STAFF RECOMMENDATION

NCPC File No. 6426

**WALTER REED ARMY MEDICAL CENTER, MAIN SECTION
AMPUTEE ADVANCE TRAINING CENTER AND INTERIM BUILDING
PRELIMINARY AND FINAL SITE AND BUILDING PLANS
14th and Fern Streets, NW, Washington, DC**

January 29, 2004

EXAMPLE OF INTERIM AMPUTEE ADVANCE TRAINING CENTER MODULAR STRUCTURE

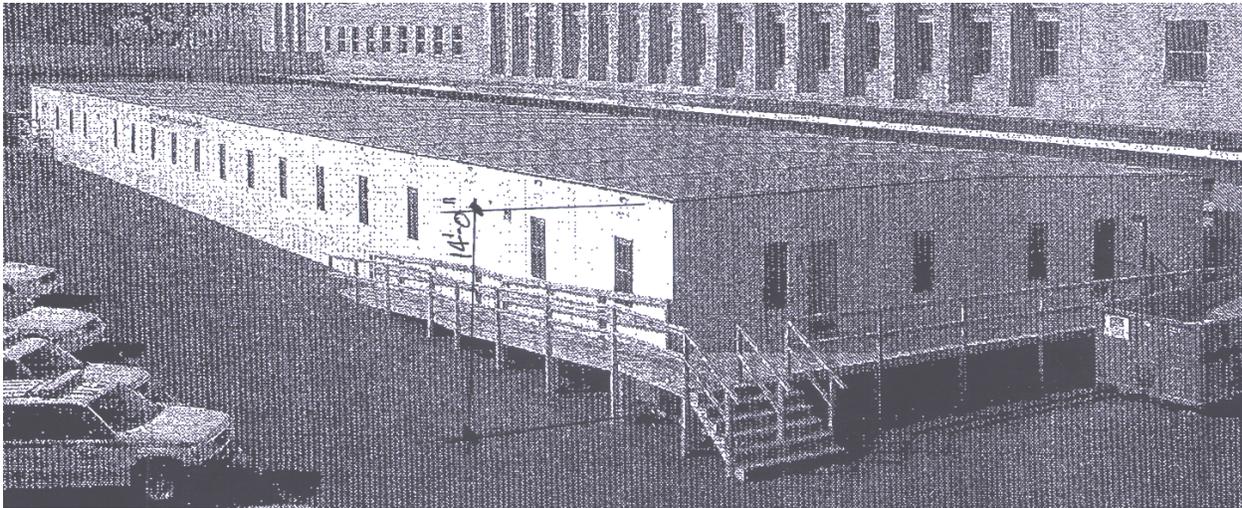
Staff **recommends approval** of the preliminary and final site and building plans for the interim temporary building, with one condition. NCPC staff analysis concludes the new modular structure is a necessary and required minor addition to the property to address a critical and pressing medical activity. Staff finds the single level building configuration, with its flat roofline, compatible with the limited open space terrain at the north side of the main hospital building. Because it is a small-size development of an interim nature, staff feels its location is acceptable. The staff notes, however, that the temporary structure should be approved with the proviso that it is to be removed upon completion and opening of the permanent Amputee Advanced Training Center.

Approves the preliminary and final site and building plans for the interim Amputee Advance Training Center modular building, as shown on NCPC Map File No. 71.20(38.00)-41293, with the condition that the structure is to be removed upon the completion and opening of the permanent Amputee Advanced Training Center, and

PERPECTIVE SKETCH -VIEW SHOWING VISIBLE SURFACE ELEMENTS OF THE AMPUTEE ADVANCED TRAINING CENTER

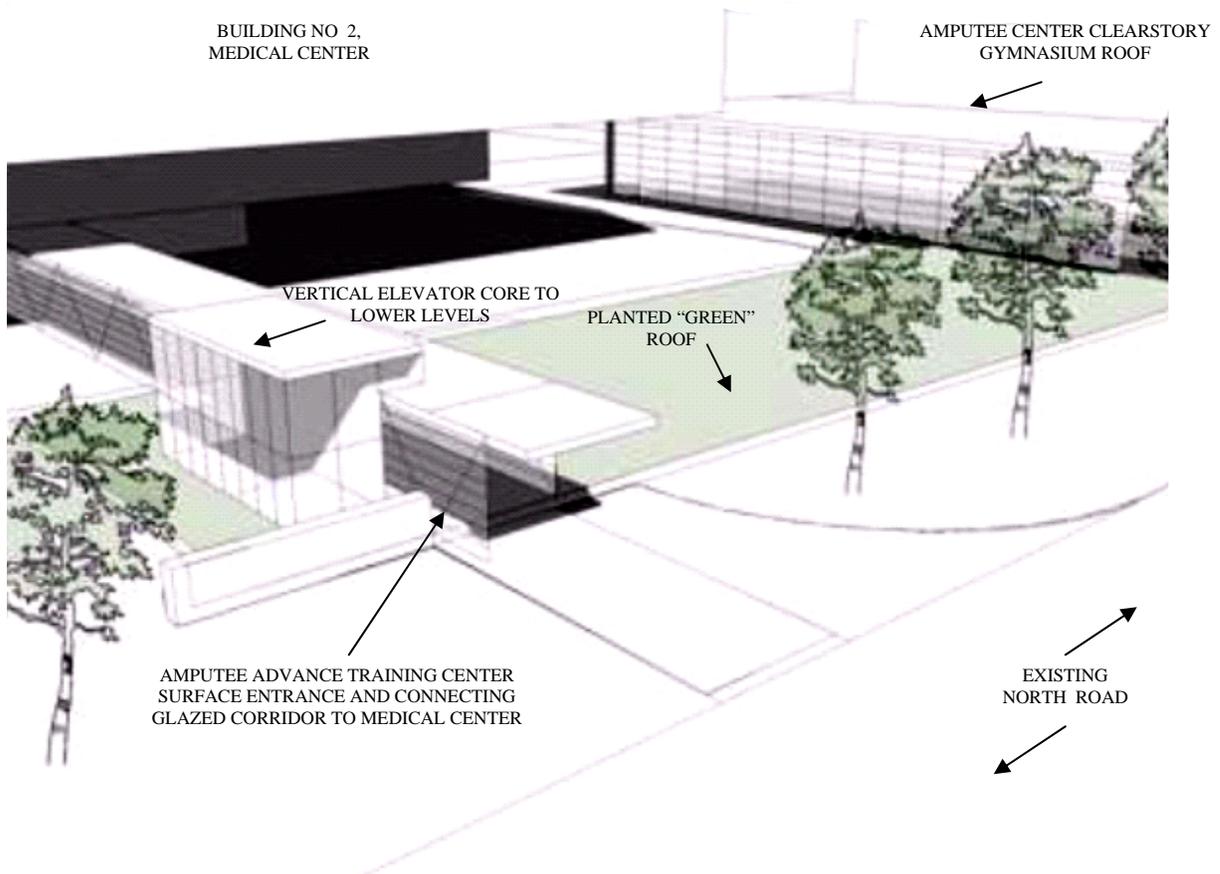
Staff further **recommends preliminary approval** of the permanent Amputee Advance Training Center. Staff finds the Army has clearly initiated an advanced and commendable site compatible design. The initial preliminary design is a prime example of utilizing a sustainable design philosophy which can encourage decisions at each phase of the design process and that will reduce negative impacts on the environment and the health of the future occupants. Such an integrated approach positively impacts all phases of a building's life-cycle, including design, construction, and operation and the staff commends the Army's approach to this project and the use of the greenscape roof.

Aside from the above noted endeavor, however, staff believes further detailed design documentation must be provided to the Commission to meet the submission requirements of final approval. Currently, that level of project construction design development has not been

demonstrated in the submission, and the staff believes at least a 70 percent level of design information should be achieved by the Army for the permanent Amputee Advanced Training Center final approval review. This information should include both the site design development and the final building design information in accordance with Commission review requirements. At the time of submission, the Army is also reminded that samples of all final project finishes and colors should be provided for the permanent building design.

Approves the preliminary site and building plans for the permanent Amputee Advance Training Center and request that the Walter Reed Army Medical Center design team apply the U.S. Army SPiRiT building certification program to the building design effort if possible.
